Re: Indian Point Unit No. 2
Docket No. 50-247

SUBJECT: Indian Point Unit No. 2 Spent Fuel Pool Storage Capacity Increase
(TAC 72962)

ADDITIONAL INFORMATION REGARDING THE INDIAN POINT 2
INCREASE IN SPENT FUEL POOL STORAGE CAPACITY
(RESPONSES TO REFERENCE 1)

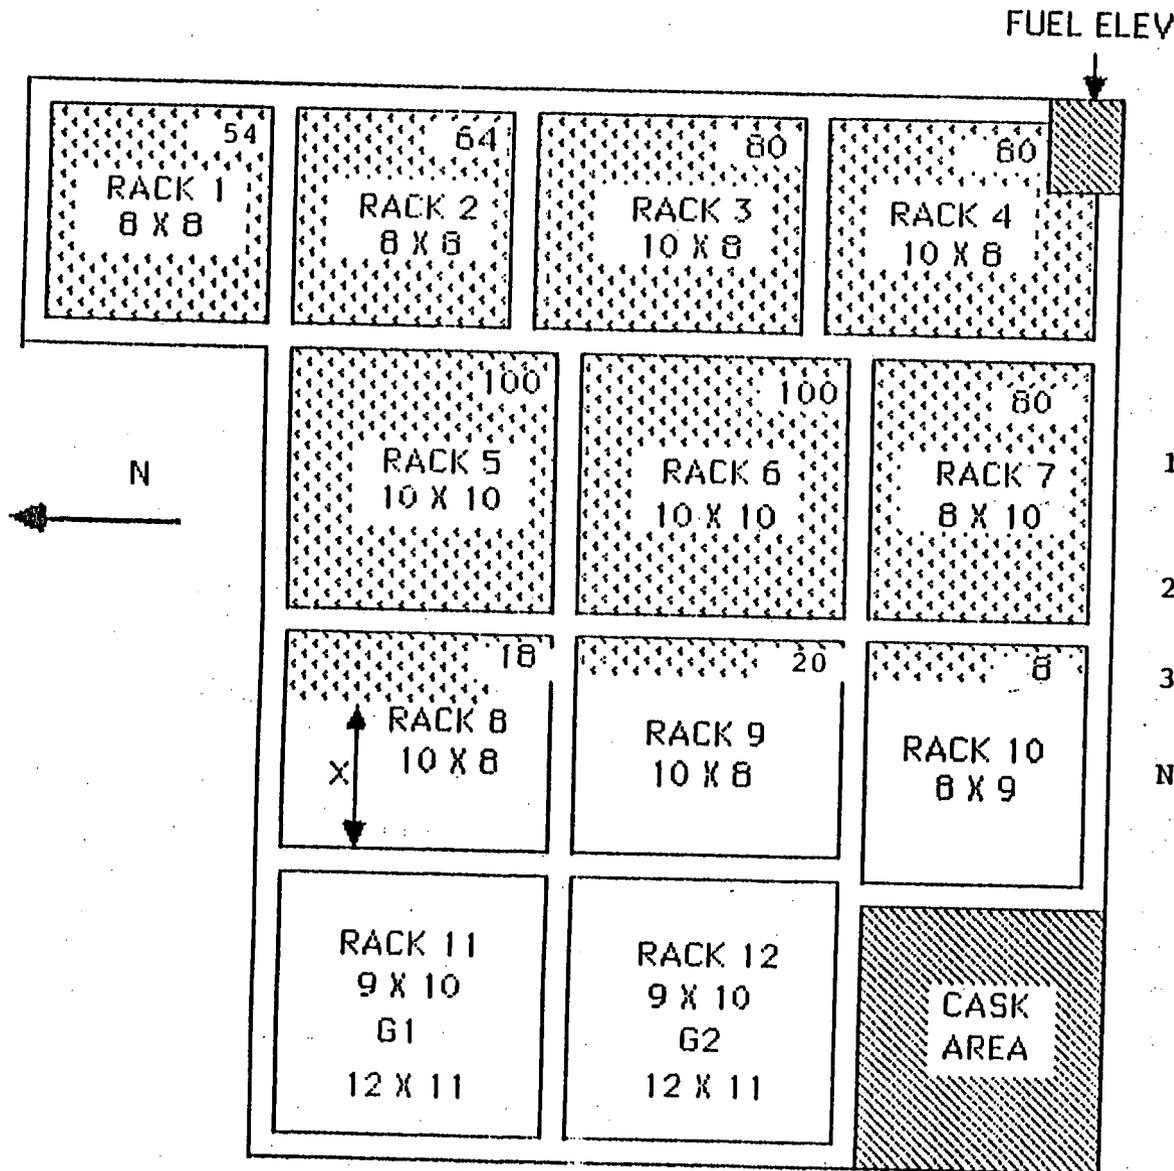
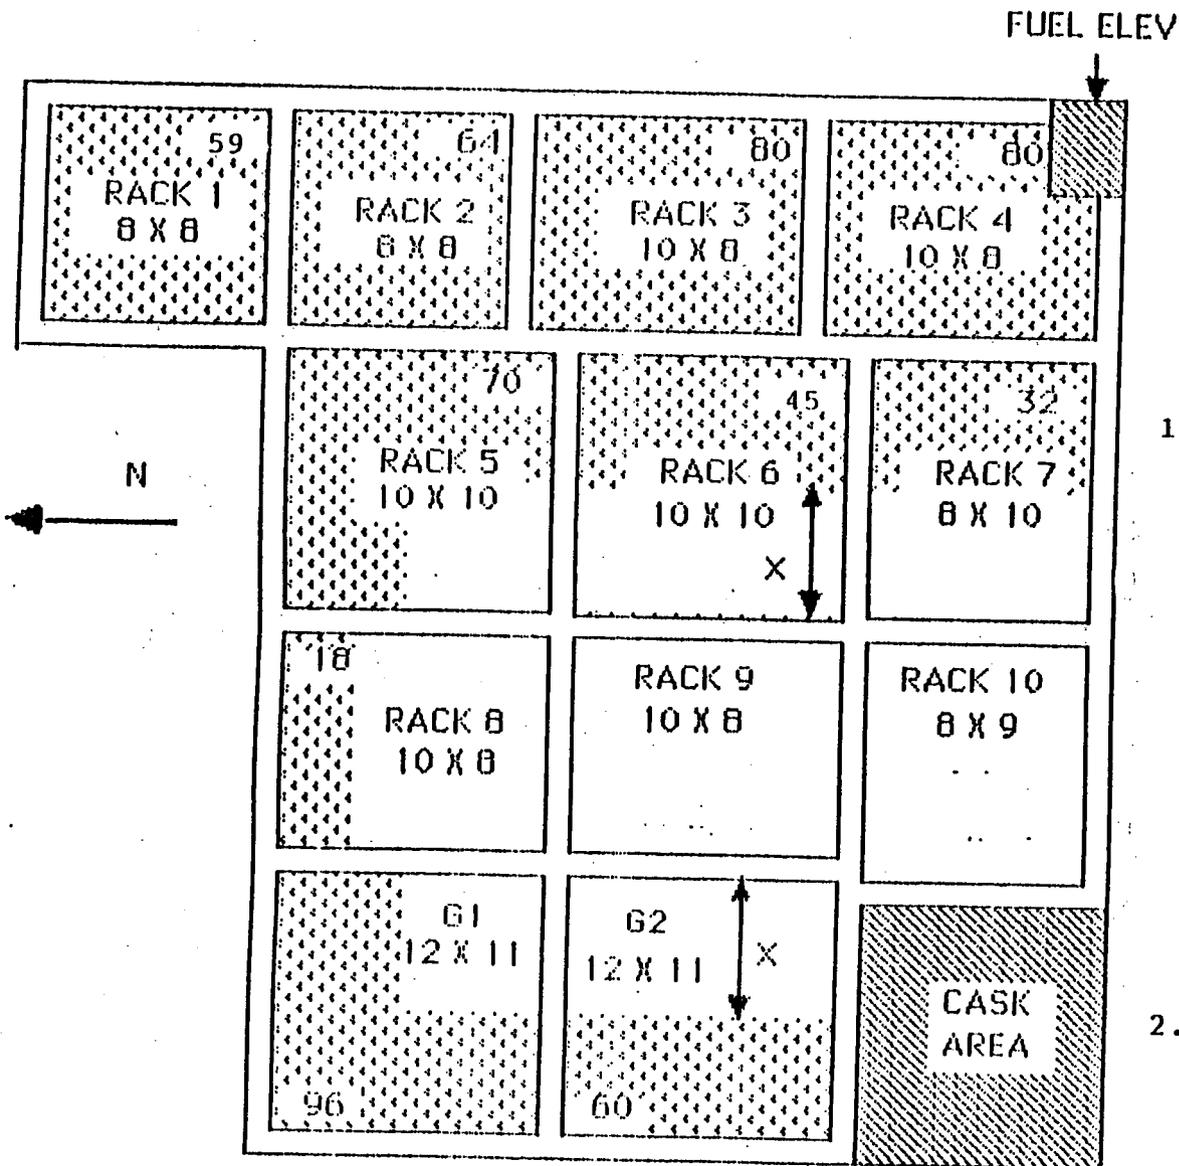
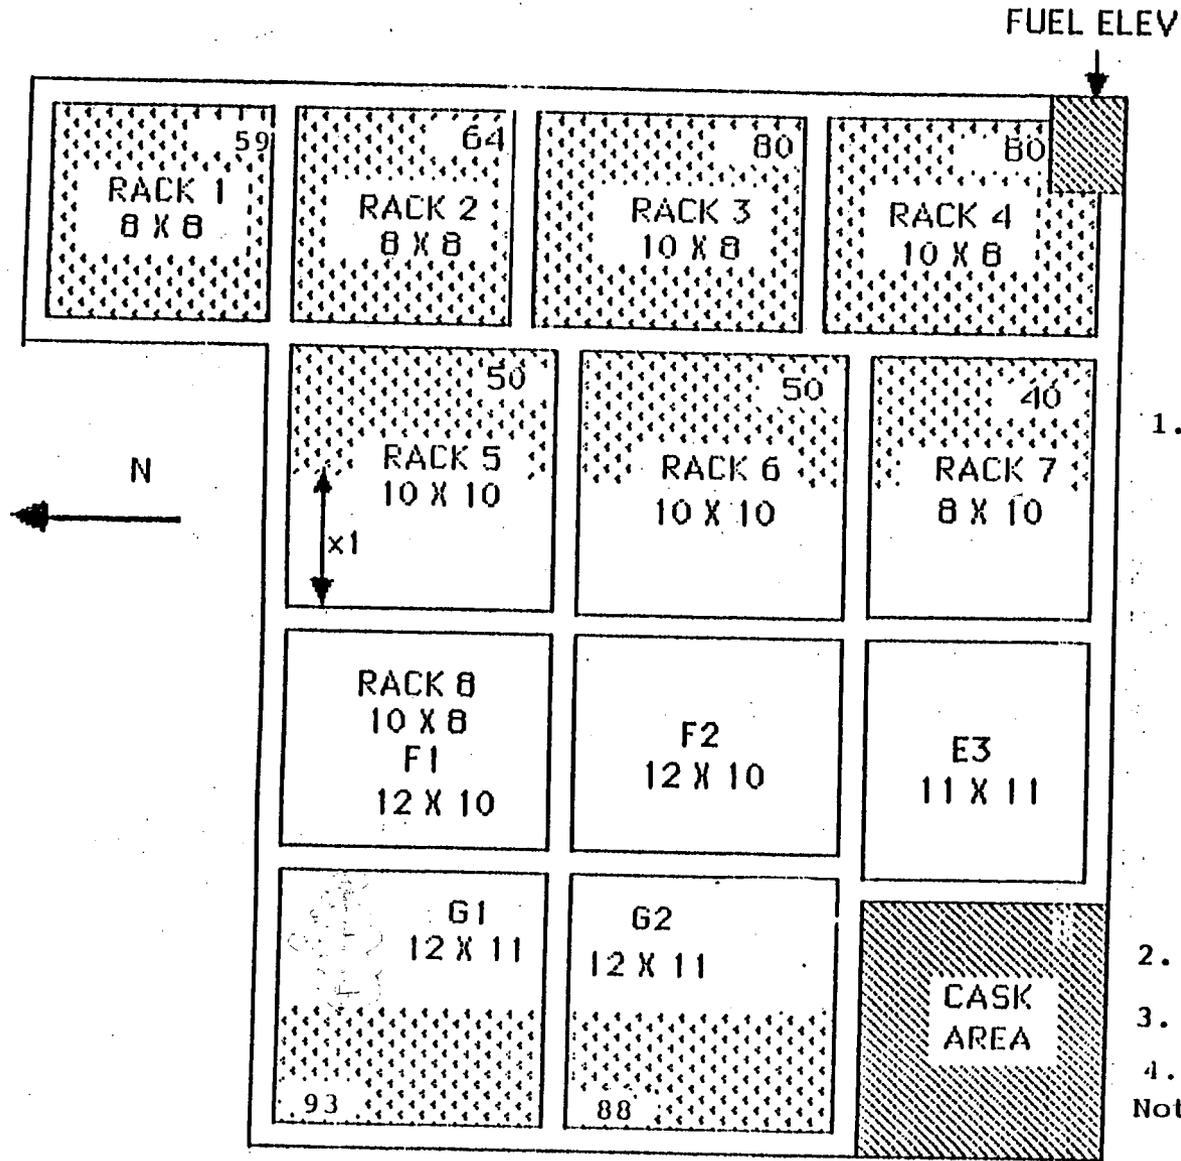
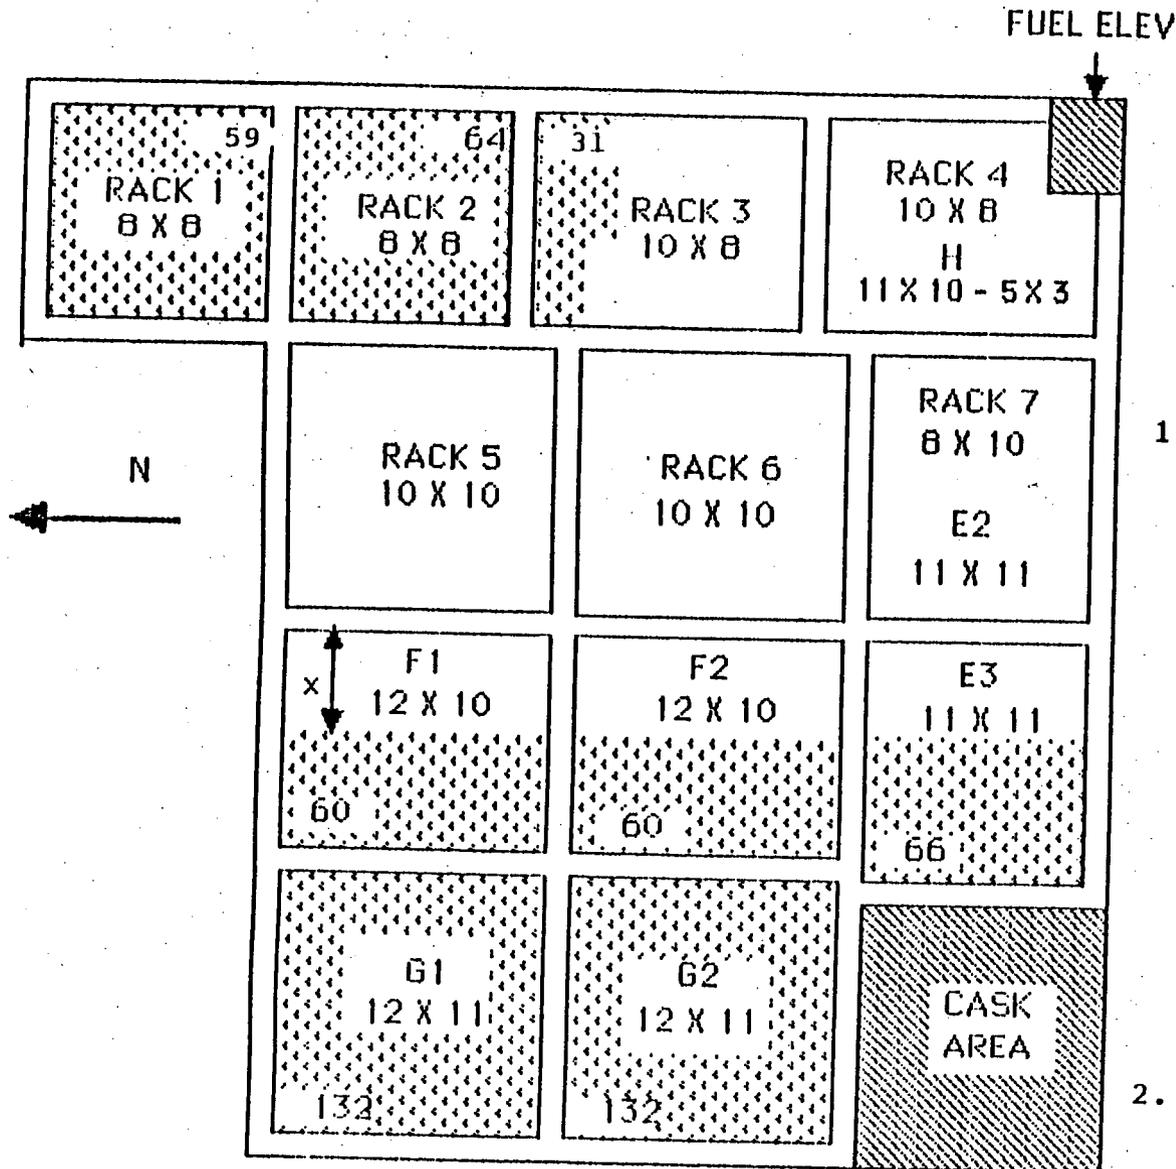
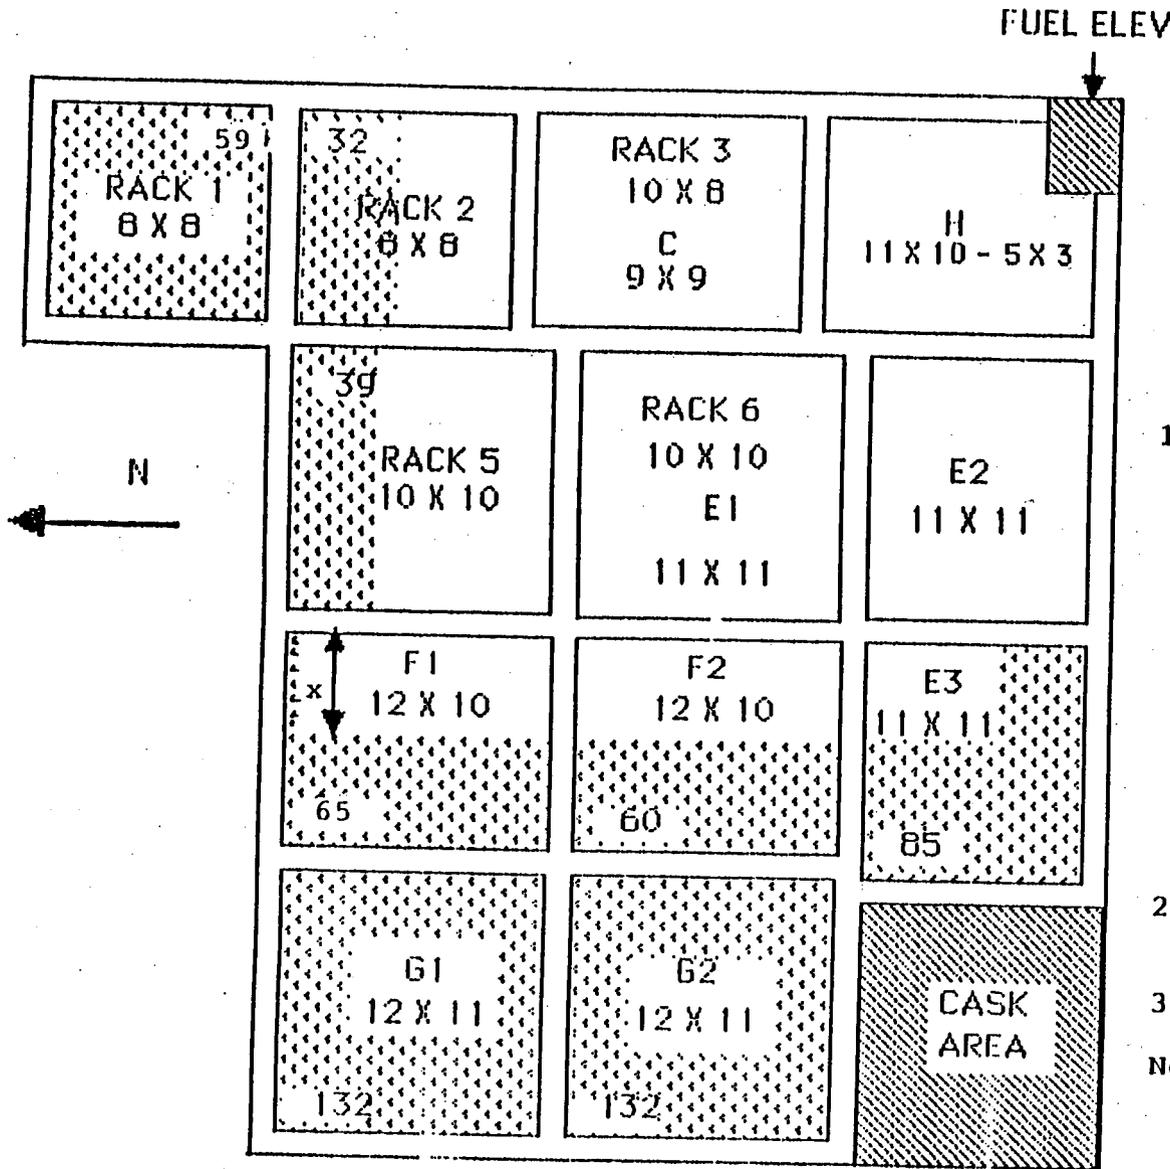
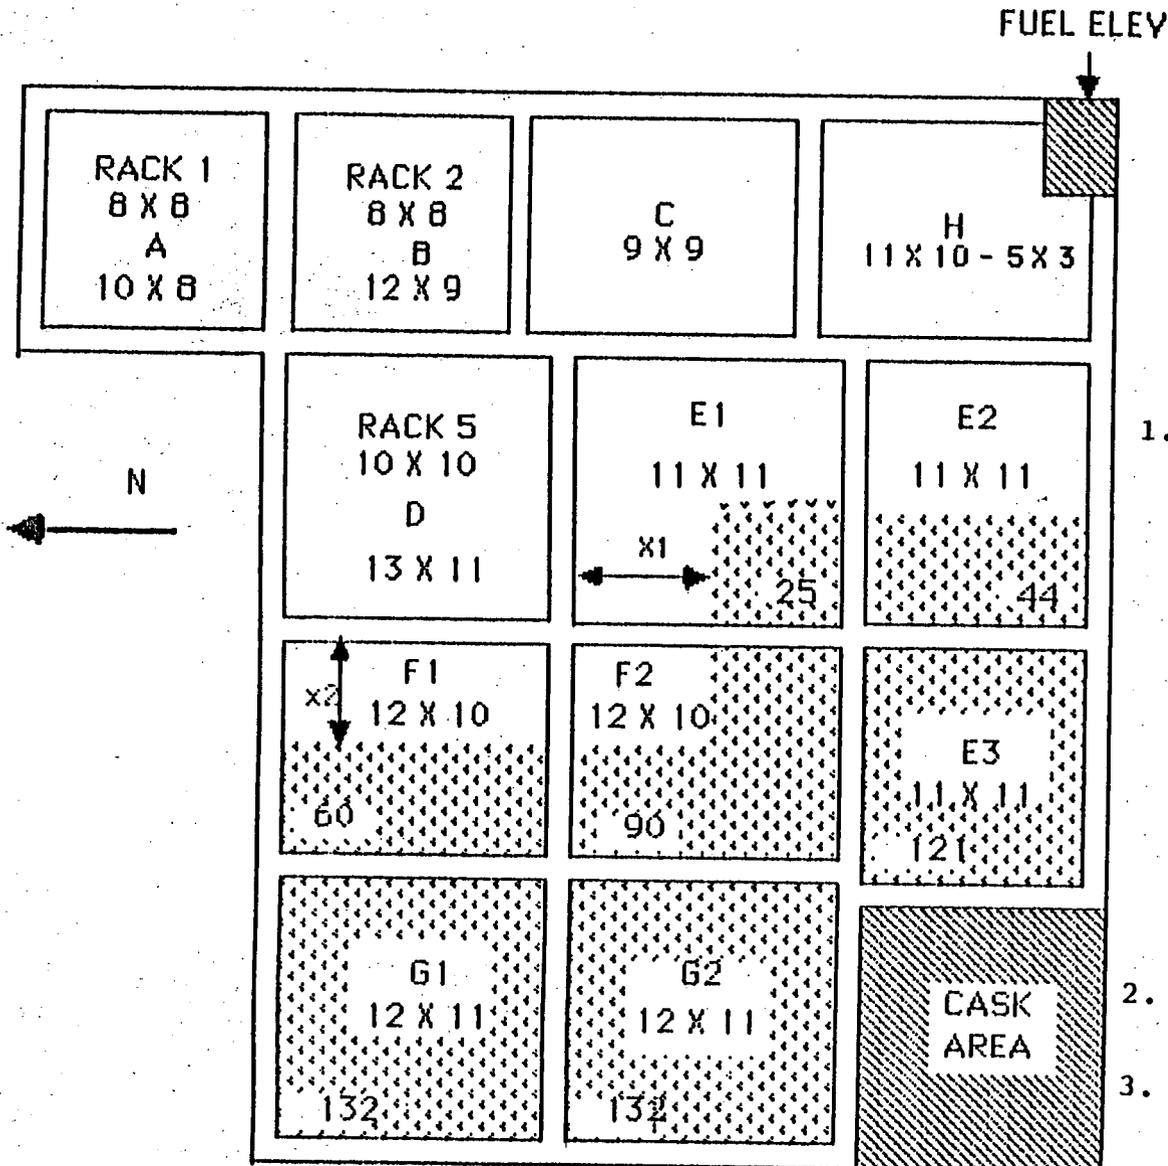
Question 2. Provide an outline of the procedure to be used for (1) moving the spent fuel assemblies (SFAs) already in the pool, (2) removal of the old spent fuel storage racks, (3) installation of the new racks and (4) replacement of SFAs in new racks. Indicate approximate minimum distances between stored spent fuel and racks during movement.

The removal and installation of the racks involves a carefully planned sequence of fuel assembly relocation followed by old rack removal and new rack placement. Figures 1 through 6 show the sequence of rack regions occupied by fuel, racks removed and racks installed in the pool. Old racks are indicated by numerals 1 through 12. New racks are designated by alphanumeric identifications used in the Licensing Report. The dimension "x" (with subscripts where necessary) indicates the shortest distance between the fuel and the new racks at each reracking stage. These figures provide proposed fuel shuffles which meet the objective of maintaining a minimum distance of four feet between stored fuel and a rack being installed. The final reshuffling plan may differ somewhat from Figures 1 through 6, but the objective of maintaining the minimum distance of four feet will be met.

- 4) Replacement of SFAs in new rack:
- o The SFAs will be placed into the new racks as required by the fuel shuffles shown in Figures 1-6 in accordance with the fuel movement procedure outlined in item 1 above.
